SERVICE BULLETIN

99

TITLE
INSPECTION AND RECTIFICATION OF RUDDER PEDAL SLIDERS
CLASSIFICATION

T67B, T67C Series, T67M (Not Works No. 1999), T67M-MkII, T67M200, T67M260 and T67M260-T3A.

FIG 1

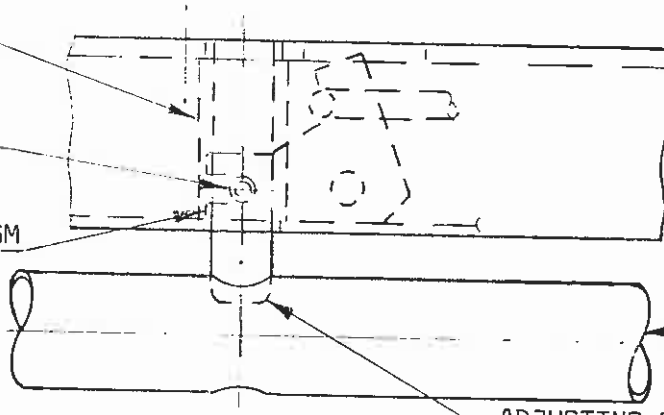
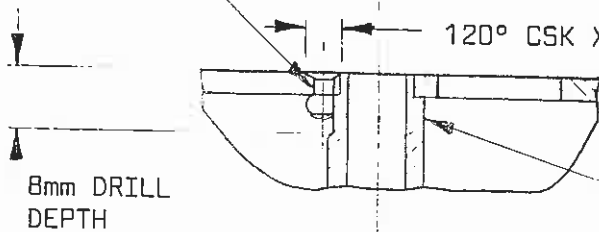
Cases have been reported, during ground maintenance work, of the failure of a rudder pedal adjusting mechanism whereby the pedal position cannot be adjusted. Upon investigation it was found that the adjusting pin retaining bush had rotated causing the roll pin in the adjusting pin to disengage from the lifting mechanism fork.

1. Remove each pedal/slider assembly and inspect for:
 - i) Correct operation of adjusting pin lifting mechanism, ie roll pin is engaged in fork, and for looseness of bush, ref Fig. 1.
 - ii) Check for any play in upper slider to lower slider attachment rivets, ref Fig. 2.
 - iii) Check for any play in adjusting mechanism attachment rivets, ref Fig. 3.

4. Modification Procedure:
 - 4.1 Remove pedal pad from slider mechanism.
 - 4.2 Addition of adjusting pin retaining bush anti turn rivet. Fig. 1.
 - 4.2.1 Ensure adjusting mechanism is aligned and is functioning correctly, with roll pin fully engaged in lifting mechanism fork.

- 4.2.2 Position jig JT67G-45-227 onto upper slider, jig will only fit correctly one way.
 - 4.2.3 Drill 2.85mm dia (No.33 drill) 8mm deep hole. Fig. 1, Section A-A.

- 4.2.4 Remove jig and csk 120° x 5mm dia.
 - 4.2.5 Using pop rivet gun fit pop rivet 126-24-031 (Tucker TLP/K319BS).
 - i) Ensure head is flush with surface of slider.

- ii) Ensure adjusting pin and mechanism operate freely.
 - 4.3 Upper slider to lower slider attachment rivets.

FIG 2
UPPER SLIDER TO LOWER SLIDER, PEDAL MECHANISM JOINT

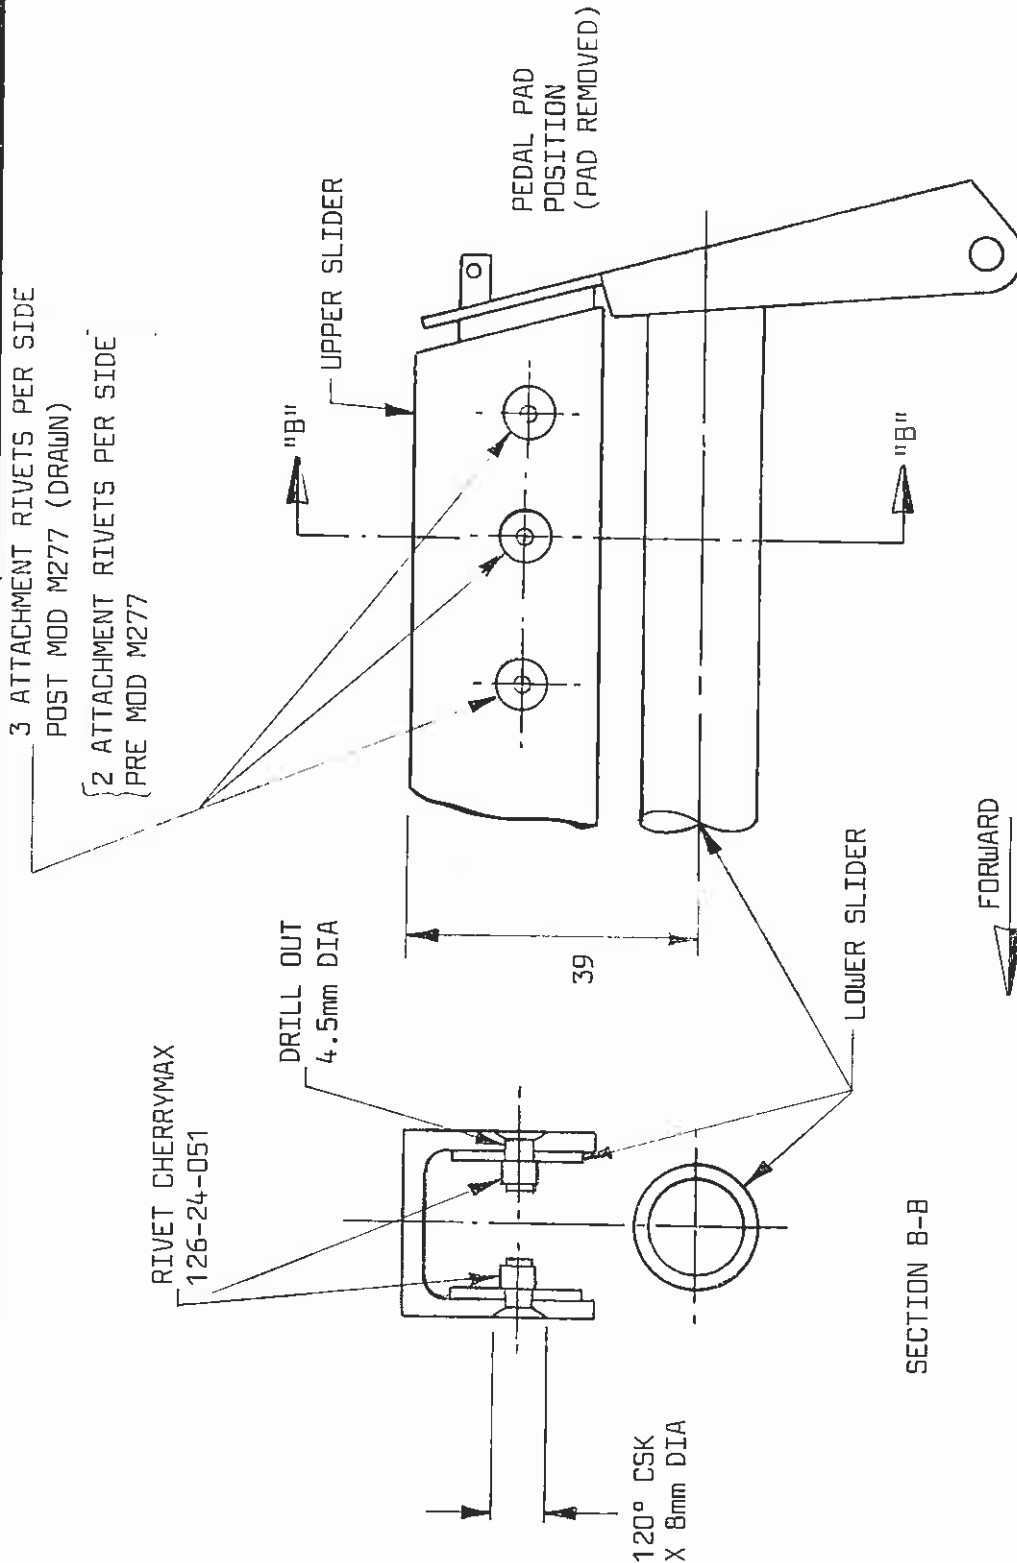
Cases have also been reported of loose rivets in the upper slider to lower slider joint.

- 1) On Pre Mod M277 aircraft, there are 4 attaching rivets in total. Replace rivets in accordance with the following sequence:

Drill out forward rivet one side and re-rivet, followed by diagonally opposite rivet etc.

- 2) On Post Mod M277 aircraft there are 6 attaching rivets in total. Replace rivets in accordance with the following sequence:

Drill out forward rivet one side and re-rivet, followed by diagonally opposite aft rivet, re-rivet. Repeat with opposite forward and aft rivets. Finally centre rivet one side then opposite side centre.

- 4.3.1 Drill out existing rivets using 4mm dia drill. Ensure drill does not penetrate too far into slider assy.

- 4.3.2 Drill hole out to 4.5mm dia oversize and csk 120° x 8mm dia (1mm deep).

Prior to rivetting ensure upper slider is parallel (Ref 39mm dimension) to and in line with lower slider, and that the rivet head will be flush.

- 4.3.3 Rivet using suitable Cherry Max Rivet gun and rivet 126-24-051 (Cherry CR 3556P-5-3).

- 4.3.4 After rivetting check alignment and rivets for flushness. Rectify as necessary.

FIG 3
ADJUSTING MECHANISM ATTACHMENT TO SLIDER

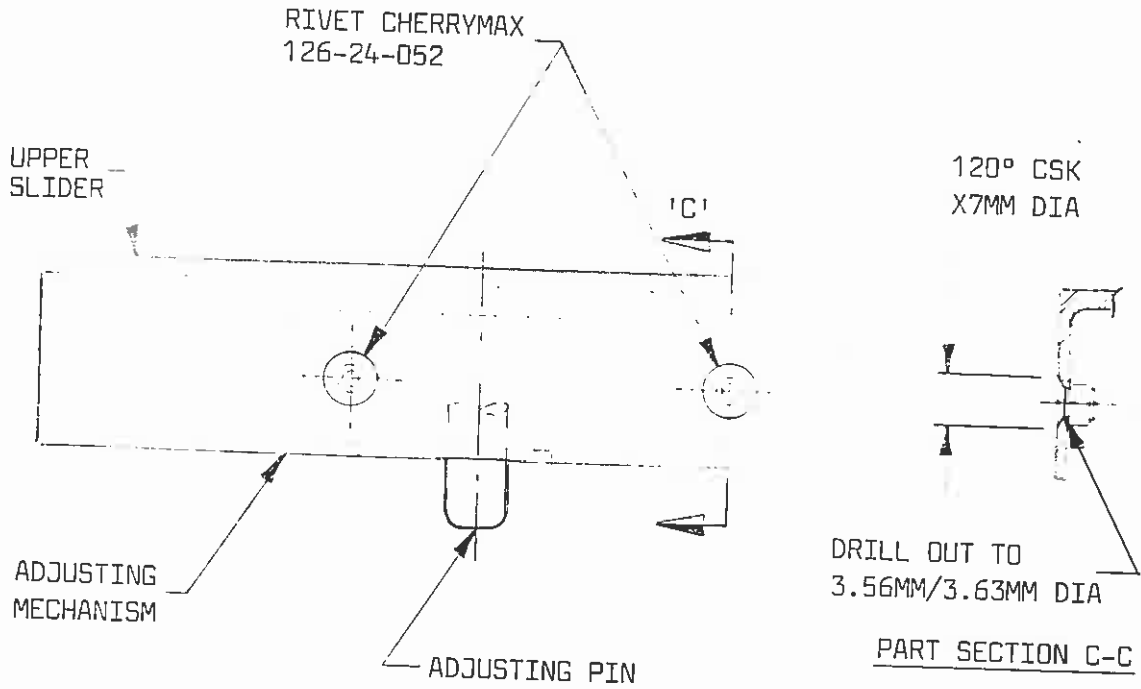
Additionally cherry type rivets may be used to replace the Tucker pop rivets attaching the pedal adjusting mechanism to the slider should the original have any play in them. This latter action is mainly a preventative action.

- 4.4 Adjusting mechanism attachment rivets, ref Fig. 3.
